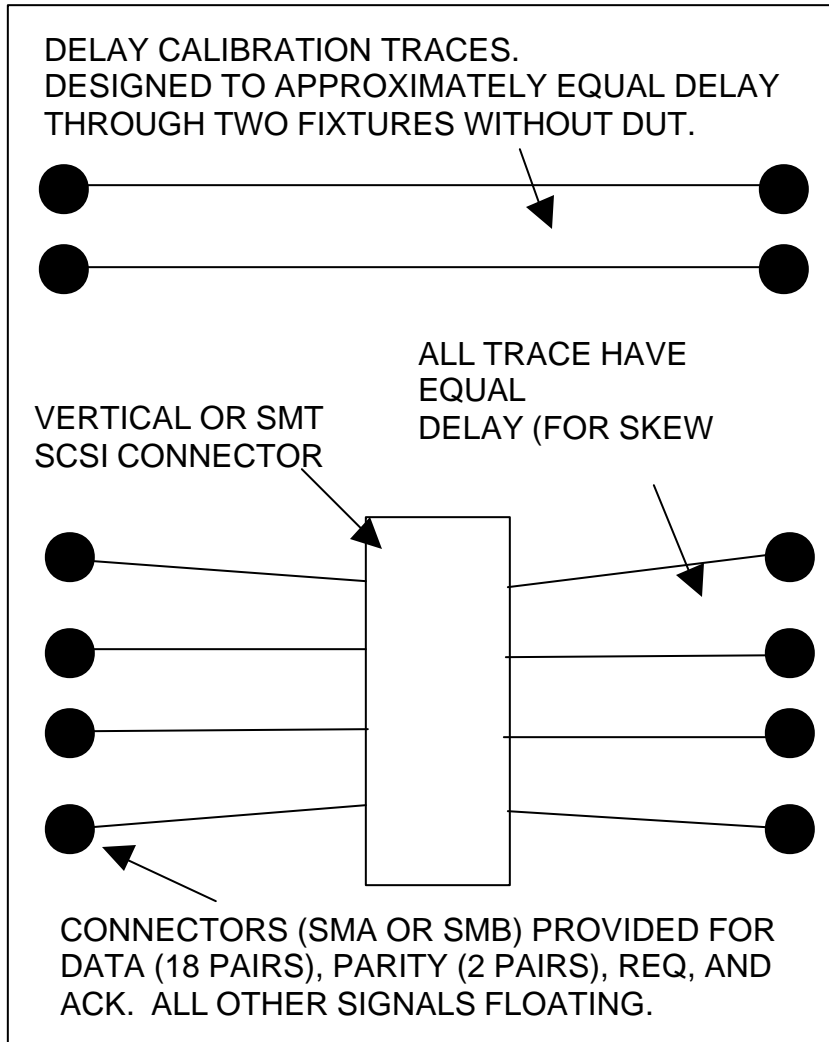
- a) Says "The test fixture may be constructed of semi-rigid coax, microstrip PCB, or stripline PCB." BUT, the figure shows something very different. Eliminate "semi-rigid coax".
- b) The fixture shows chip capacitors. These would ruin TDR risetime if large values. If low values, the capacitors are useless. In either event, they should not be there.
- c) Bulk cable and PCB impedance and Td measured with 'other lines floating'. Here, tying other lines to ground through 61 Ohms risks a different answer for assembly versus bulk. Resistors should probably not be on this fixture.

- d) Suggest entirely new figure 19 FIX_ASY_1 (below, created in PowerPoint). Perhaps the existing figure will be used as new figure (Standard Load).
